MEMORANDUM

FROM: Upal Barua, PE, PTOE, Development Officer, Transportation Public Works Department (TPW)

SUBJECT: **WildHorse Planned Unit Development Amendment Application**

Attachment 2 – Austin Strategic Mobility Plan Roadway Network Plan

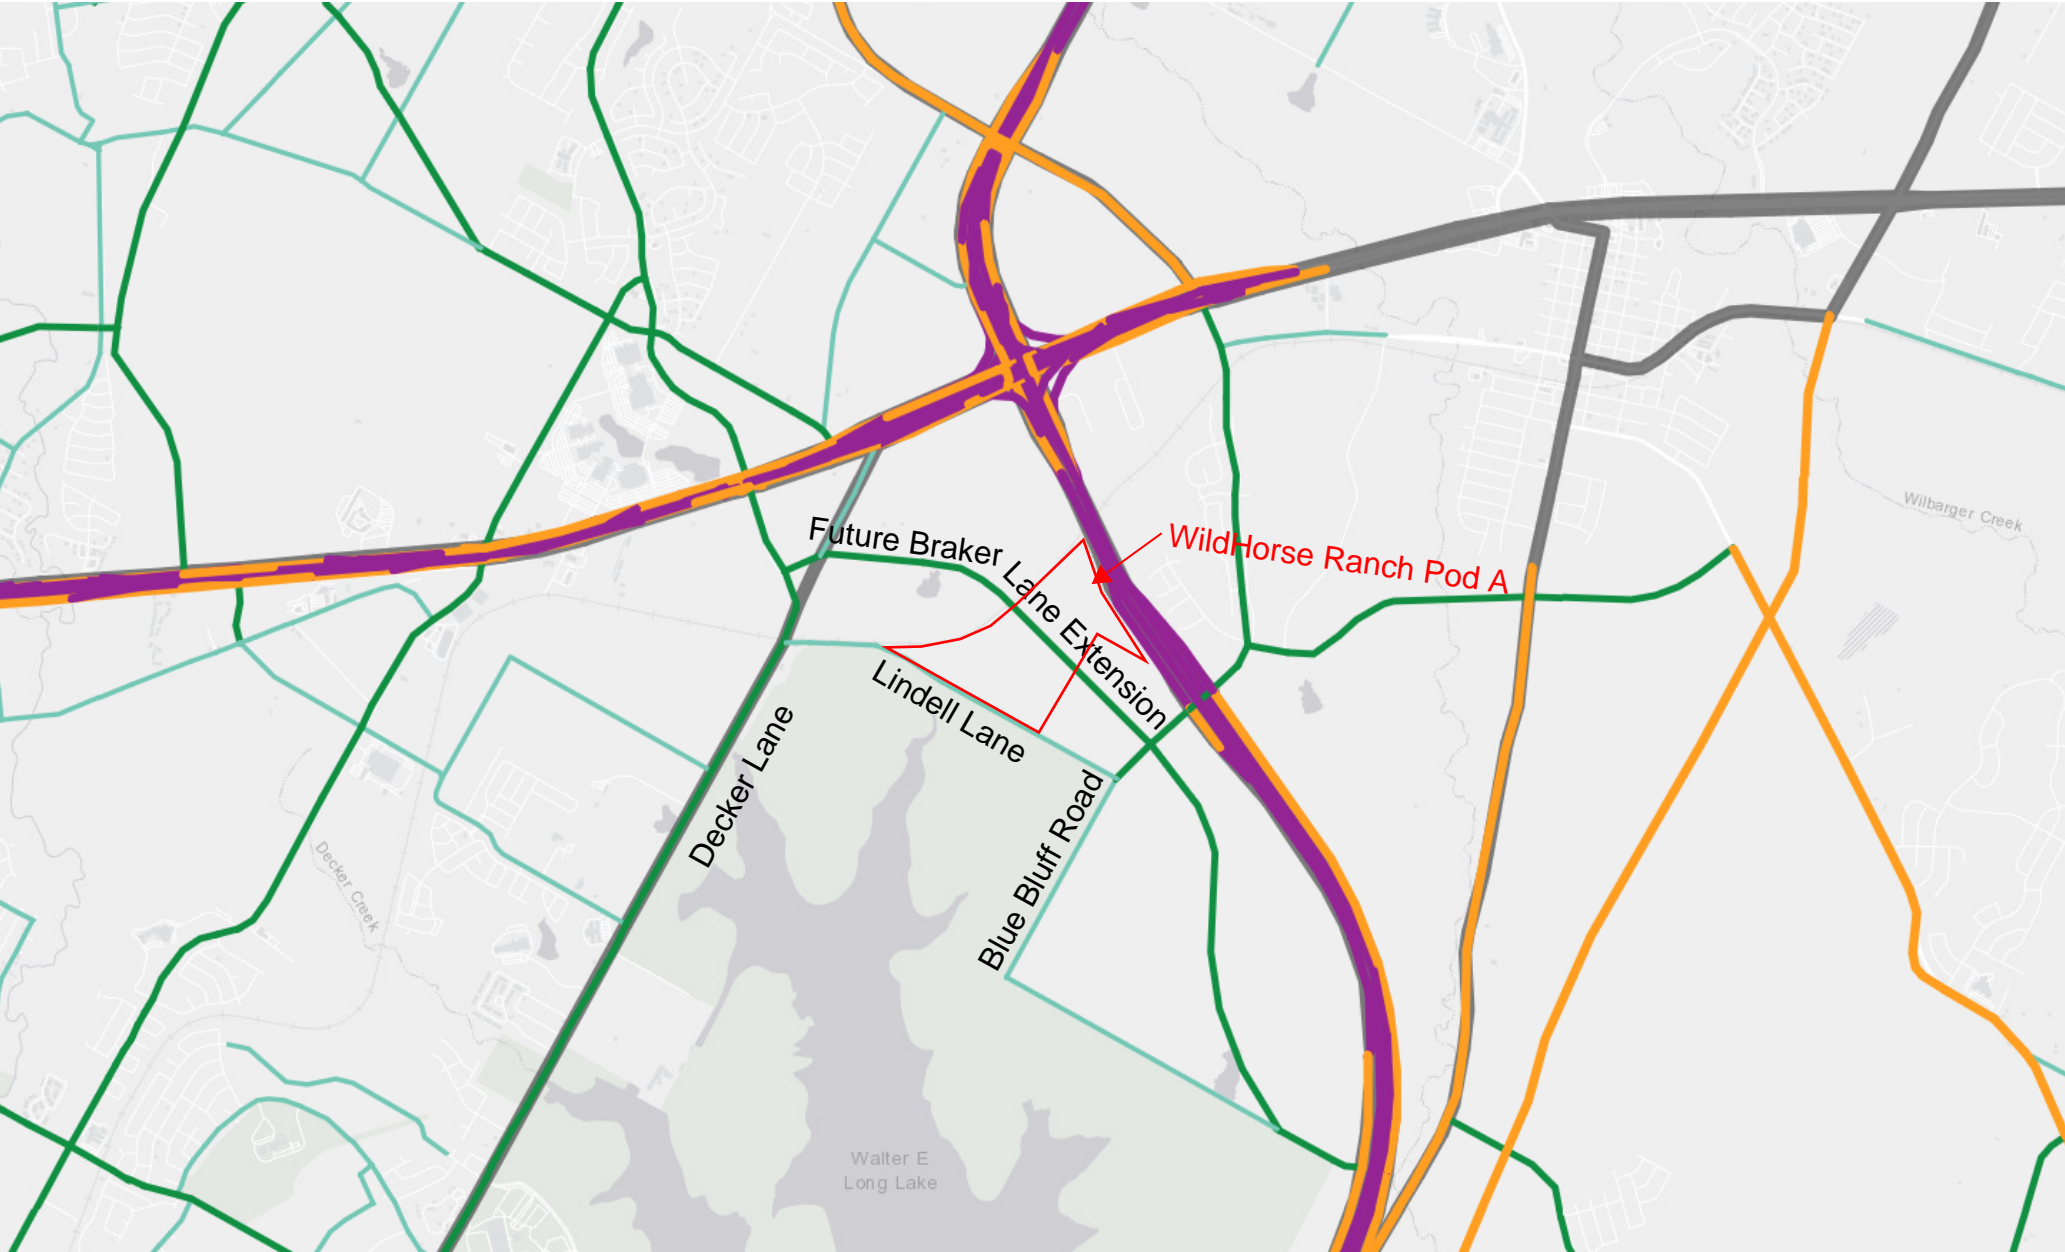
In order to more adeptly address the changes in mobility conditions in the future, the ASMP was adopted by City Council in 2019. The adoption process of ASMP included extensive public engagement and coordination with other local agencies including Travis County to agree on future mobility needs and potential alignments for existing and proposed roadways. Upon its approval, the ASMP superseded the AMATP as the City's transportation plan. Based on the changes in mobility conditions, the ASMP updated East Braker Lane alignment and separated it from Lindell Lane adjacent to the WildHorse PUD site. At that time, no subdivision or site plan had been submitted for Pod A on the WildHorse PUD site. The current alignment is shown in **Attachment 2**.
